MFN 09-307

Docket No. 52-010

Subject: **Response to Portion of NRC Request for Additional Information  
Letter No. 334 Related to ESBWR Design Certification Application  
– Site Characteristics - RAI Number 2.3-4 S05**

**RAI Number 2.3-4 S05**

**Figure 2.3-4(1) Typical Sketch of Roof Drain**

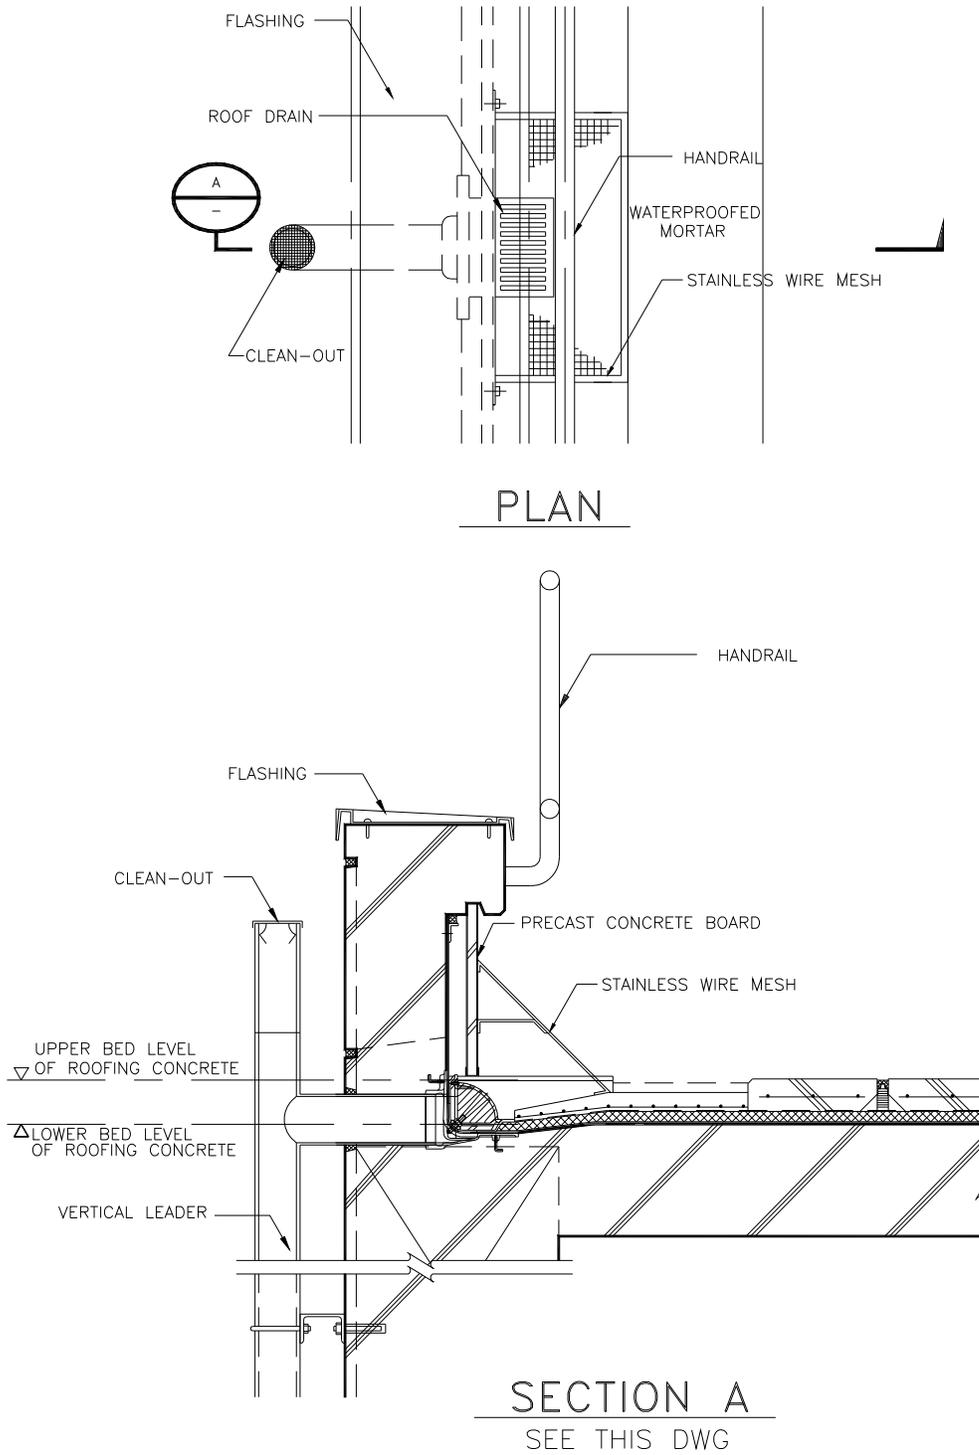
*Footnote 5 to DCD Tier 2 Table 2.0-1 states that the roof scuppers and drains are designed independently to limit water accumulation on the roof to no more than 100 mm (4 in) during PMWP conditions. Please provide details of the design of the roof scuppers and drains demonstrating that an antecedent 100-year recurrence interval ground level snow pack of 2394 Pa (50 lbf/ft<sup>2</sup>) will not clog both the roof scuppers and drains and prevent no more than 100 mm (4 in) of water accumulating on the roof.*

In the ESBWR Standard Plant, roofs are provided with two independent drainage systems. The roof drains form the primary drainage system and the scuppers form the secondary drainage system. As required by the International Plumbing Code (invoked by IBC-2003) and ASCE 7-02, only the blockage of the primary system is postulated when designing the secondary system and for calculating the rain load on the roof.

Figures 2.3-4(1) and (2) show typical sketches of the roof drain and overflow scupper. The design of the roof scuppers and drains follows ASCE 7-02. The elevation of the overflow scupper is set such that the average water depth does not exceed 100 mm (4 in.) in case the roof drains are clogged by snow, ice, or other obstructions.
